**TRANSMITTAL OF MEETING HANDOUT MATERIALS FOR
IMMEDIATE PLACEMENT IN THE PUBLIC DOMAIN**

NRC MEETING WITH ISA 67.04 COMMITTEE

NRC'S PERSPECTIVE ON ALLOWABLE VALUE

ISA S67.04 Methods of Determining Trip Setpoints and Allowable Values

Method 3:

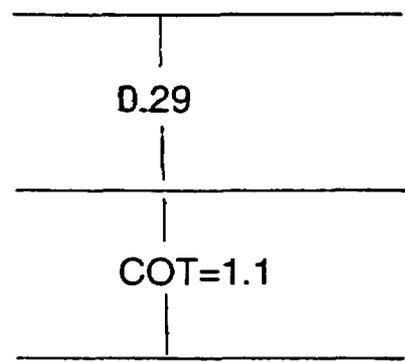
Method 3, and method 3 with additional margin, as shown in the examples, are not acceptable methods for calculating Allowable Values because the methodology permits the "as found" trip setpoint to be greater than 5.15 psig without declaring the channel inoperable. The staff notes that if non-COT uncertainties were added to the "as found" TSP, the instrument channel would exceed its analytical limit and therefore would not preserve the safety limit. Therefore, the channel will not meet the 10 CFR 50.36 requirements for LSSS. However, if the methodology includes a check calculation to provide assurance that the AV is still satisfied by providing a large enough allowance to account for those uncertainties not measured during the test, then method 3 and method 3 with additional margin would be acceptable.
